Access Compliance Report

Public Rights-of-Way

Intersection ID: 13035	Main Street: W_CARSON_BV	Cross Street: WINNIFRED_ST	Location: NE
ADA ID: CCA140AA4F6D	Ramp Type: Directional1	Initial Pass/Fail: Fail	Overall Compliance: No
Severity Score: 1.25			
Codes/Mitigation Info/Possible Solution		Field Measurements/Component Compliance

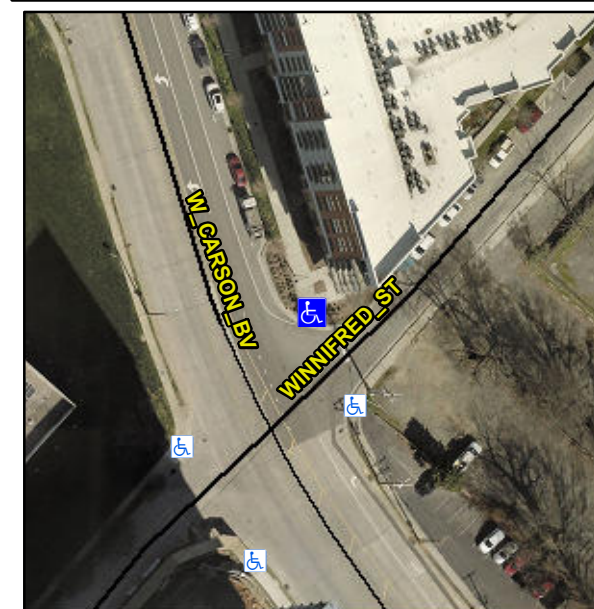
R304.5.3

Remove & Replace Entire Ramp.
